ORNL/NRC/LTR-92/15

Contract Program: **Technical Support for the Reactor Systems Branch (L1697/P2)**

Subject of Document: **Licensing Basis for Long-Term Solutions to BWR Stability
Proposed by the BWR Owners' Group**

Type of Document: **Technical Evaluation Report**

Figure A.1. Comparison between corewide decay ratios calculated by LAPUR and FABLE.

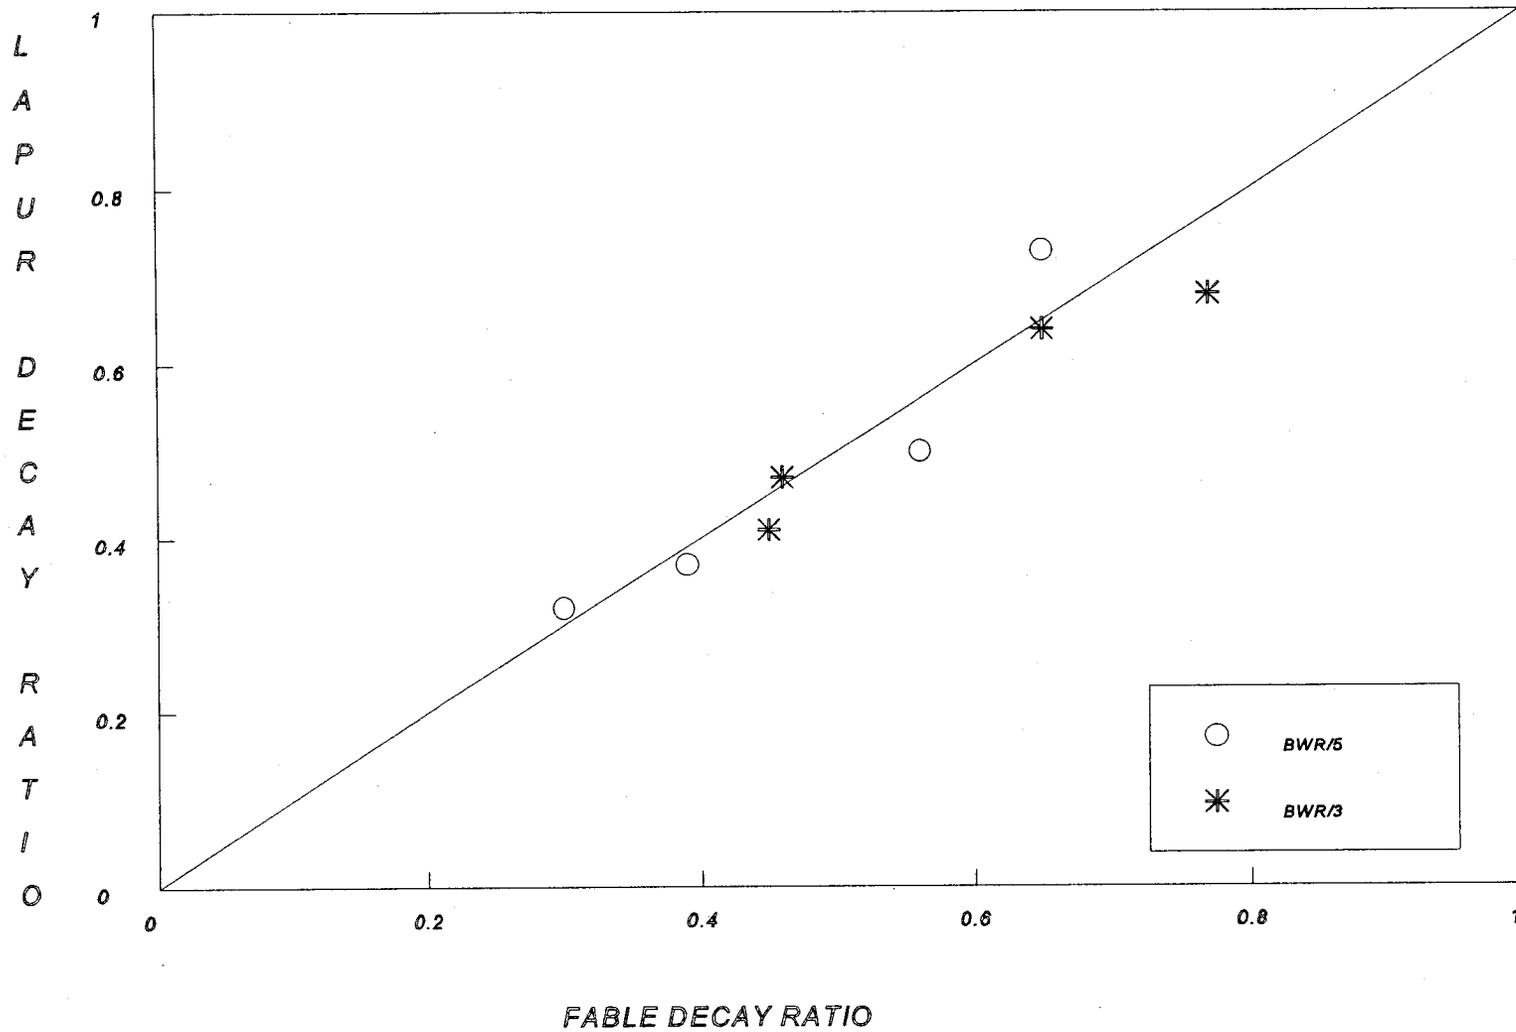
A series of audit calculations were performed with the LAPUR code to verify the results presented by the BWROG that were based on FABLE/BYPSS calculations. All relevant input data used in the FABLE/BYPSS was made available for this review, and we set up LAPUR input decks that were representative of the conditions modeled by FABLE. The main result of these calculations is presented in Table A.1 and Figs A.1 and A.2. We observe that the maximum difference between LAPUR- and FABLE-calculated decay ratios is 0.09. This can be considered as excellent agreement and representative of the differences in modeling of both codes.

Figure A.5. Comparison between equilibrium-cycle exclusion region and the exclusion region for the specific operating conditions of a BWR/5 instability event.

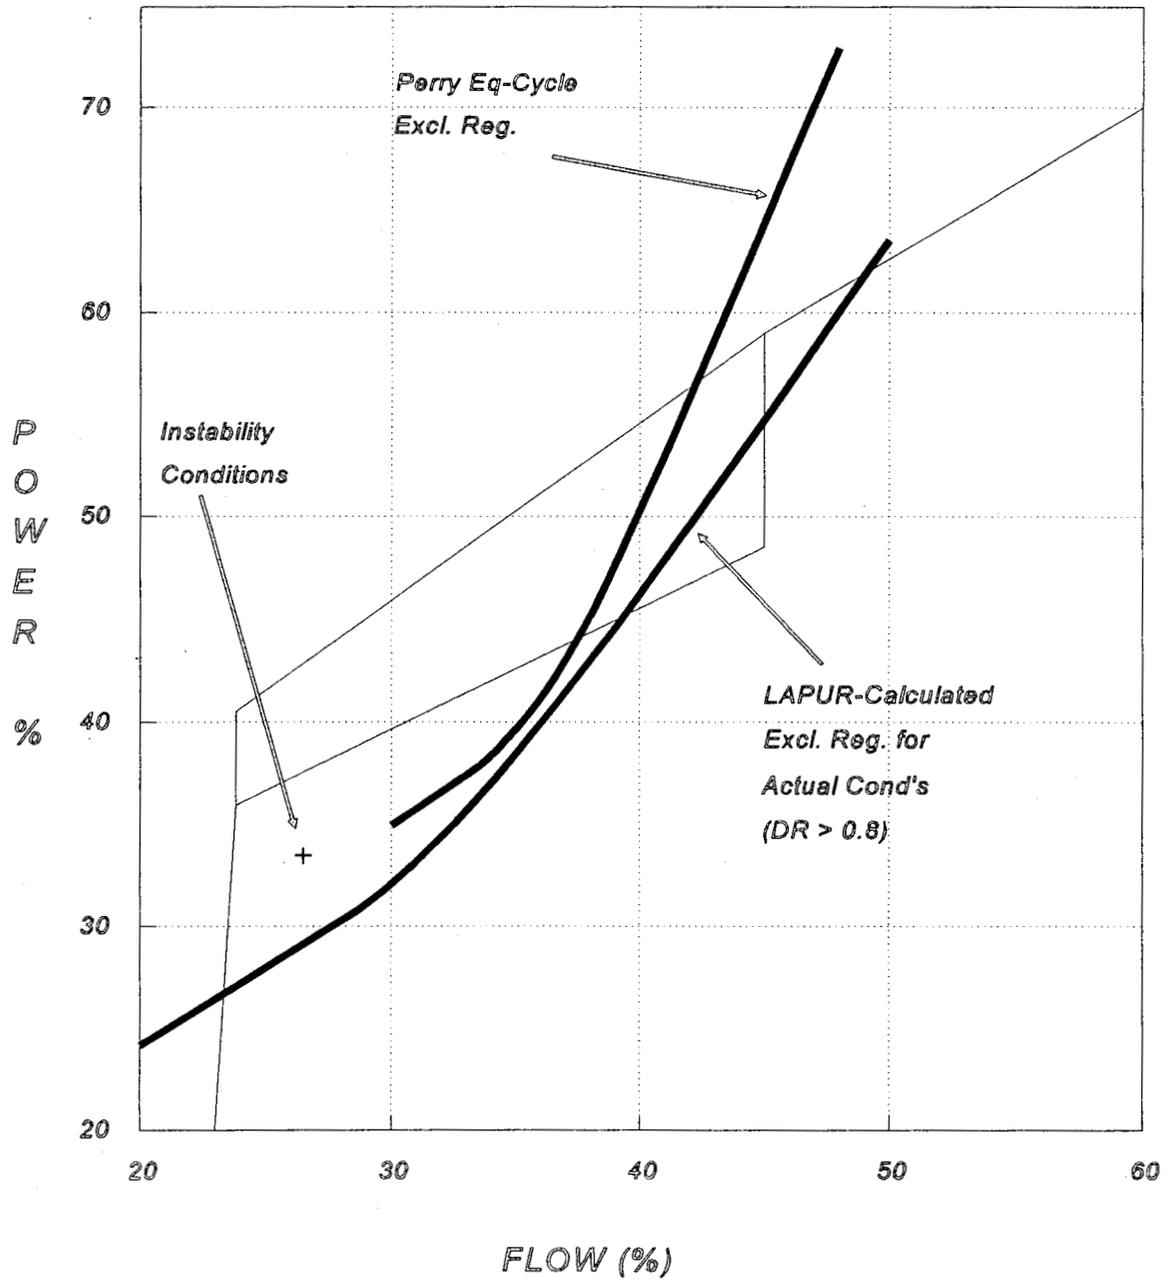
Of particular concern is how the reload procedures will be used to evaluate startup power distributions. For example, the root cause of a recent instability event in a BWR/5 has been determined to be the extreme radial (1.92) and axial (up to 1.87) peaking factors during the startup. This extreme power distribution was apparently not covered by the standard exclusion region calculations, which assumed a more mild radial power peaking factor. Nevertheless, the operator was allowed to have that extreme distribution without violating any thermal limits.

Figure A.5 shows a comparison of the equilibrium-cycle exclusion region for the Perry reactor (a BWR/6) and the exclusion region that results if the actual axial and power shapes from the recent BWR/5 event are used. As it can be observed, the standard BWR/6 exclusion region from NEDO-31960 is not as conservative as the actual region. Therefore, we have recommended that the BWROG must establish a criteria to limit the actual radial and axial peaking factors during startup operations to those values considered for the analyses of the exclusion region. This criteria must be based on parameters or information readily available to the operator in the control room.

12. The BWROG must establish a criteria to limit the actual radial and axial peaking factors during startup operations to those values considered for the analyses of the exclusion region. This criteria must be based on parameters or information readily available to the operator in the control room. Defining this criteria must be part of the reload confirmation analyses.
